PALO VERDE NUCLEAR GENERATING STATION, UNIT NO. 1

AMENDMENT TO FACILITY OPERATING LICENSE

Amendment No. 38  
License No. NPF-41

ENCLOSURE TO LICENSE AMENDMENT

FIGURE 3.2 - 1A  
AZIMUTHAL POWER TILT LIMIT  
VS  
THERMAL POWER  
(COLSS IN SERVICE)

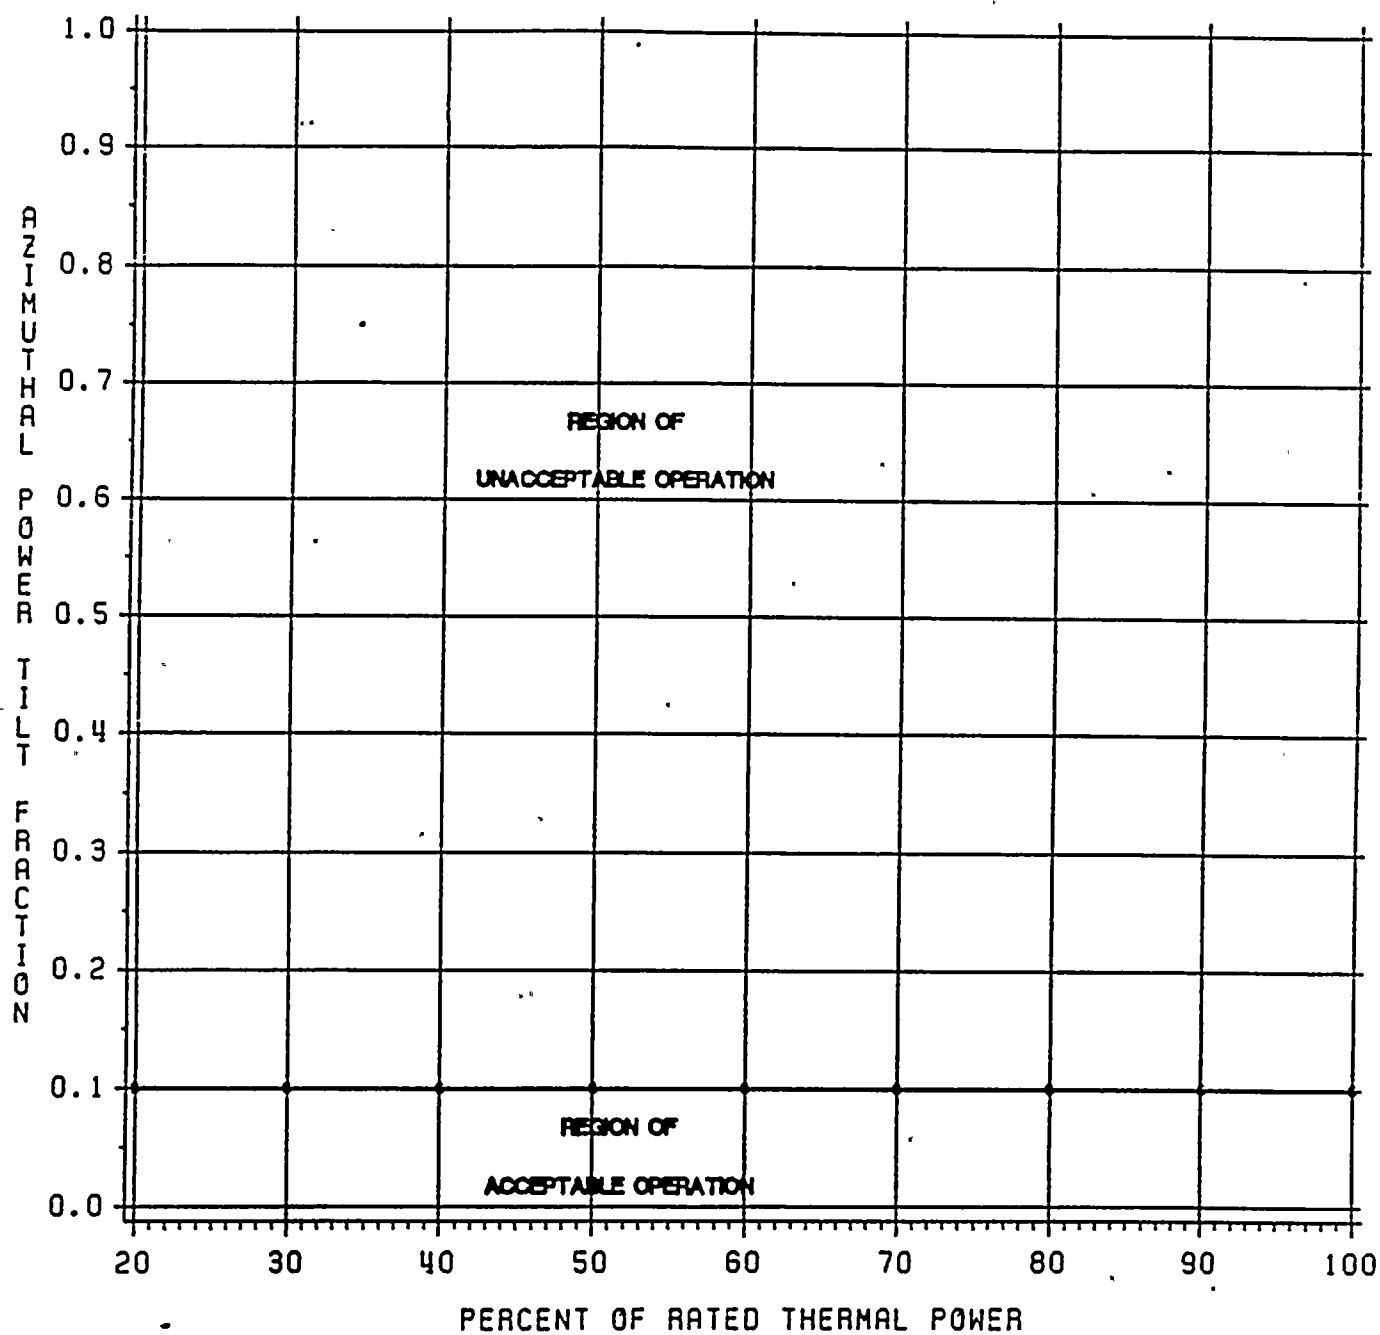
- a. The AZIMUTHAL POWER TILT Allowance used in the Core Protection Calculators (CPCs), and
- b.1. The limit in Figure 3.2-1A with COLSS in service, or
- b.2.  $T_q \leq 0.10$  with COLSS out of service.

- b. With the measured AZIMUTHAL POWER TILT determined to exceed the limit in Figure 3.2-1A with COLSS in service or 0.10 with COLSS out of service:
  1. Due to misalignment of either a part-length or full-length CEA, within 30 minutes verify that the Core Operating Limit Supervisory System (COLSS) (when COLSS is being used to monitor the core power distribution per Specifications 4.2.1 and 4.2.4) is detecting the CEA misalignment.

The limitations on the AZIMUTHAL POWER TILT are provided to ensure that design safety margins are maintained. An AZIMUTHAL POWER TILT greater than the limit in Figure 3.2-1A with COLSS in service or 0.10 with COLSS out of service is not expected and if it should occur, operation is restricted to only those conditions required to identify the cause of the tilt. The tilt is normally calculated by COLSS. A minimum core power of 20% of RATED THERMAL POWER is assumed by the CPCs in its input to COLSS for calculation of AZIMUTHAL POWER TILT. The 20% RATED THERMAL POWER threshold is due to the neutron flux detector system being inaccurate below 20% core power. Core noise level at low power is too large to obtain usable detector readings. The surveillance requirements specified when COLSS is out of service provide an acceptable means of detecting the presence of a steady-state tilt. It is necessary to explicitly account for power asymmetries because the radial peaking factors used in the core power distribution calculations are based on an untilted power distribution.

FIGURE 3.2 - 1A.  
AZIMUTHAL POWER TILT LIMIT  
VS  
THERMAL POWER  
(COLSS IN SERVICE)

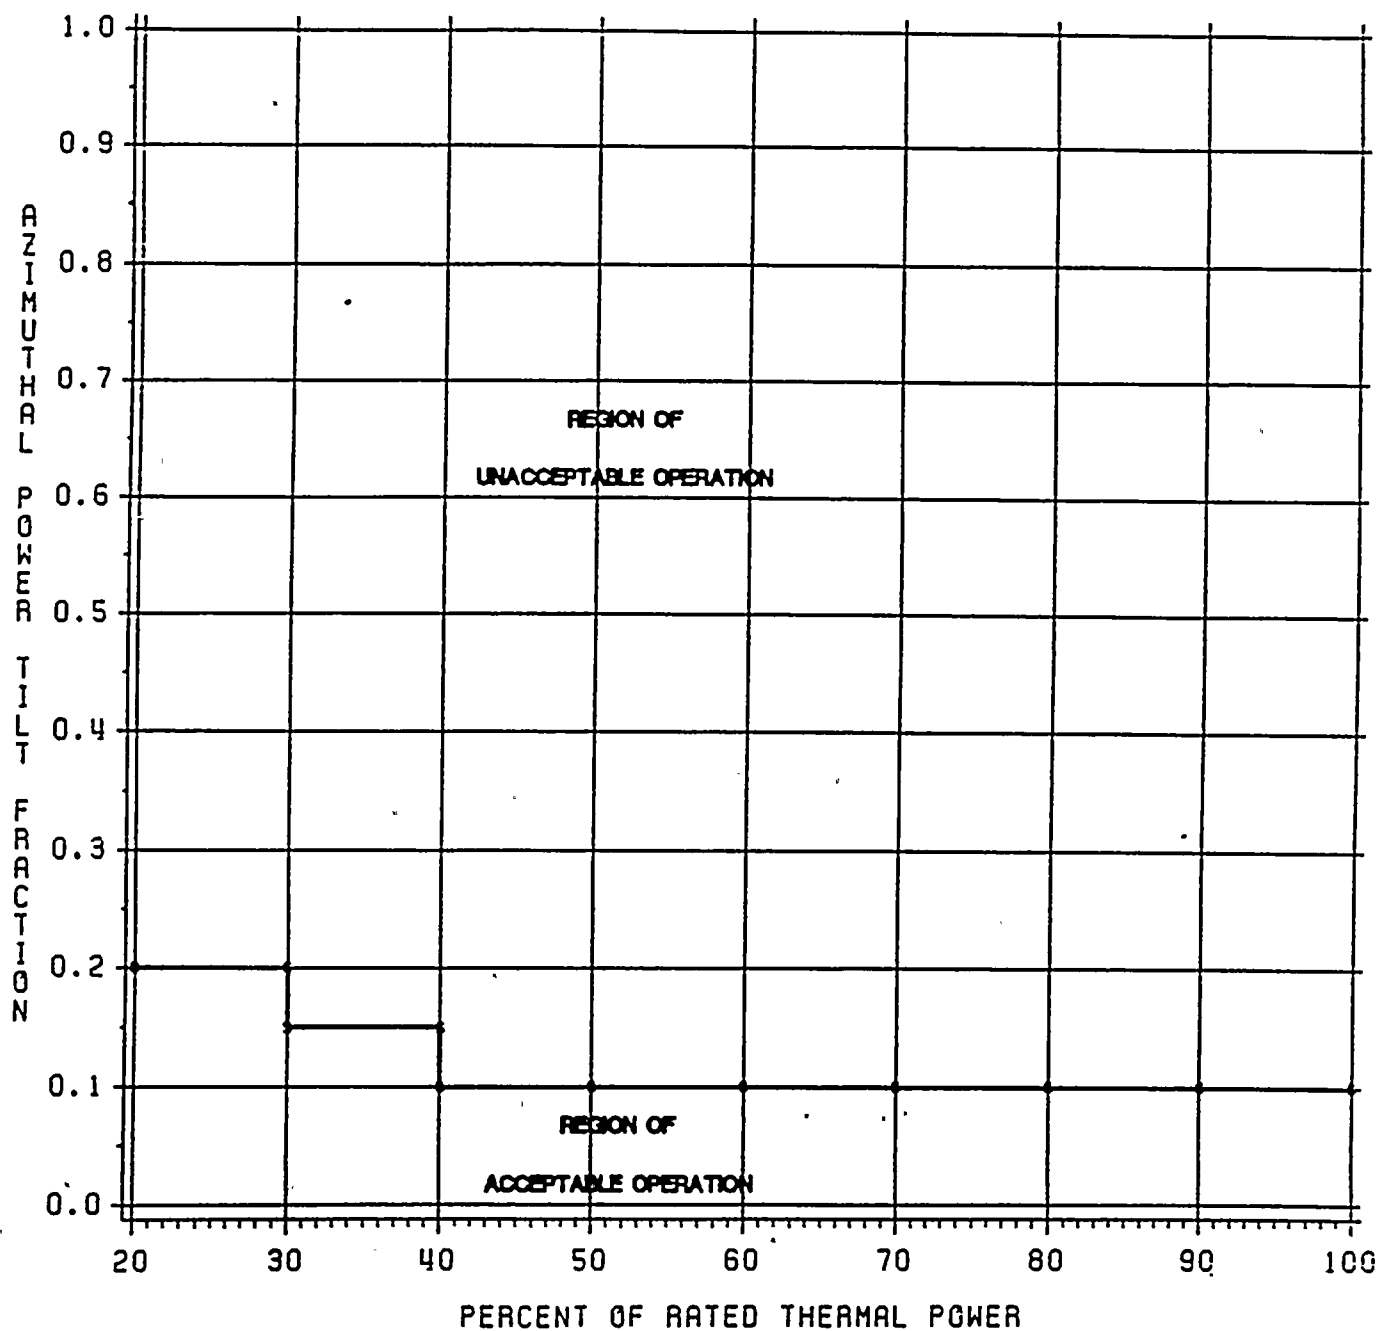
- a. The AZIMUTHAL POWER TILT Allowance used in the Core Protection Calculators (CPCs), and
- b.1. The limit in Figure 3.2-1A with COLSS in service, or
- b.2.  $T_q \leq 0.10$  with COLSS out of service.

- b. With the measured AZIMUTHAL POWER TILT determined to exceed the limit in Figure 3.2-1A with COLSS in service or 0.10 with COLSS out of service:
  1. Due to misalignment of either a part-length or full-length CEA, within 30 minutes verify that the Core Operating Limit Supervisory System (COLSS) (when COLSS is being used to monitor the core power distribution per Specifications 4.2.1 and 4.2.4) is detecting the CEA misalignment.

The limitations on the AZIMUTHAL POWER TILT are provided to ensure that design safety margins are maintained. An AZIMUTHAL POWER TILT greater than the limit in Figure 3.2-1A with COLSS in service or 0.10 with COLSS out of service is not expected and if it should occur, operation is restricted to only those conditions required to identify the cause of the tilt. The tilt is normally calculated by COLSS. A minimum core power of 20% of RATED THERMAL POWER is assumed by the CPCs in its input to COLSS for calculation of AZIMUTHAL POWER TILT. The 20% RATED THERMAL POWER threshold is due to the neutron flux detector system being inaccurate below 20% core power. Core noise level at low power is too large to obtain usable detector readings. The surveillance requirements specified when COLSS is out of service provide an acceptable means of detecting the presence of a steady-state tilt. It is necessary to explicitly account for power asymmetries because the radial peaking factors used in the core power distribution calculations are based on an untilted power distribution.

FIGURE 3.2-1A  
AZIMUTHAL POWER TILT LIMIT  
VS  
THERMAL POWER  
(COLSS IN SERVICE)

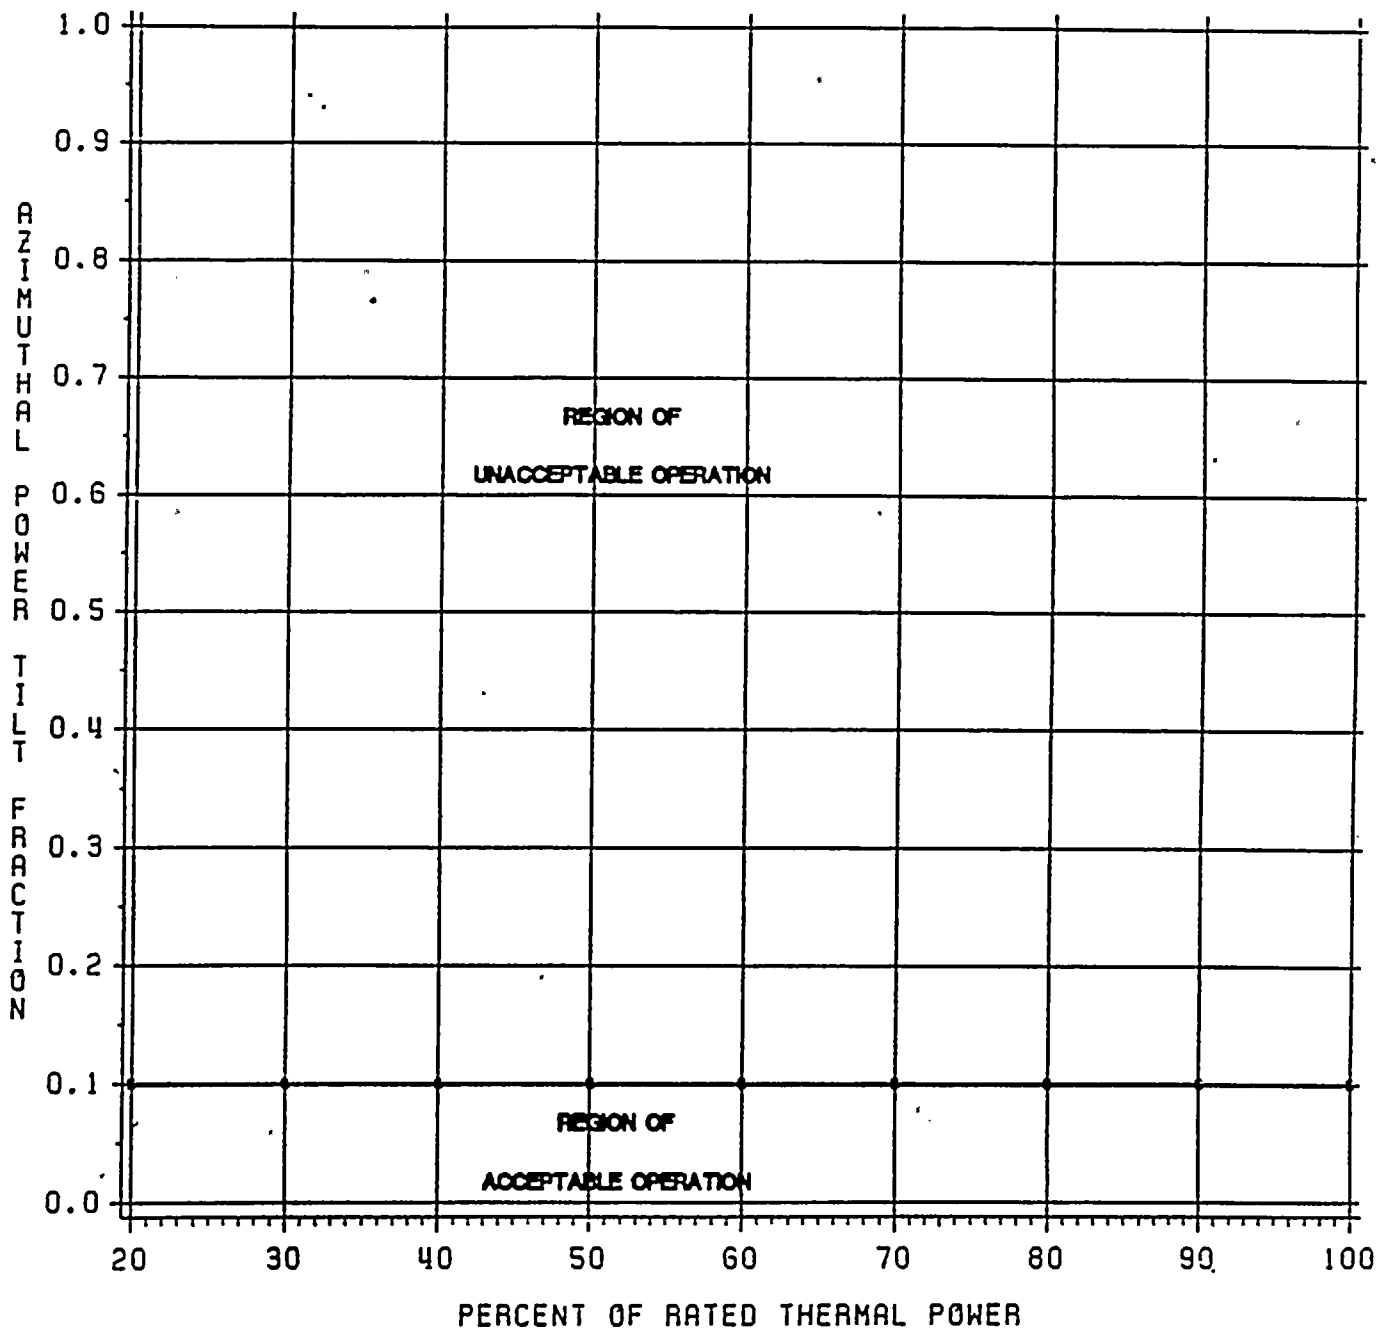
- a. The AZIMUTHAL POWER TILT Allowance used in the Core Protection Calculators (CPCs), and
- b.1. The limit in Figure 3.2-1A with COLSS in service, or
- b.2.  $T_q \leq 0.10$  with COLSS out of service.

- b. With the measured AZIMUTHAL POWER TILT determined to exceed the limit in Figure 3.2-1A with COLSS in service or 0.10 with COLSS out of service.
  - 1. Due to misalignment of either a part-length or full-length CEA, within 30 minutes verify that the Core Operating Limit Supervisory System (COLSS) (when COLSS is being used to monitor the core power distribution per Specifications 4.2.1 and 4.2.4) is detecting the CEA misalignment.

The limitations on the AZIMUTHAL POWER TILT are provided to ensure that design safety margins are maintained. An AZIMUTHAL POWER TILT greater than the limit in Figure 3.2-1A with COLSS in service or 0.10 with COLSS out of service is not expected and if it should occur, operation is restricted to only those conditions required to identify the cause of the tilt. The tilt is normally calculated by COLSS. A minimum core power of 20% of RATED THERMAL POWER is assumed by the CPCs in its input to COLSS for calculation of AZIMUTHAL POWER TILT. The 20% RATED THERMAL POWER threshold is due to the neutron flux detector system being inaccurate below 20% core power. Core noise level at low power is too large to obtain usable detector readings. The surveillance requirements specified when COLSS is out of service provide an acceptable means of detecting the presence of a steady-state tilt. It is necessary to explicitly account for power asymmetries because the radial peaking factors used in the core power distribution calculations are based on an untilted power distribution.
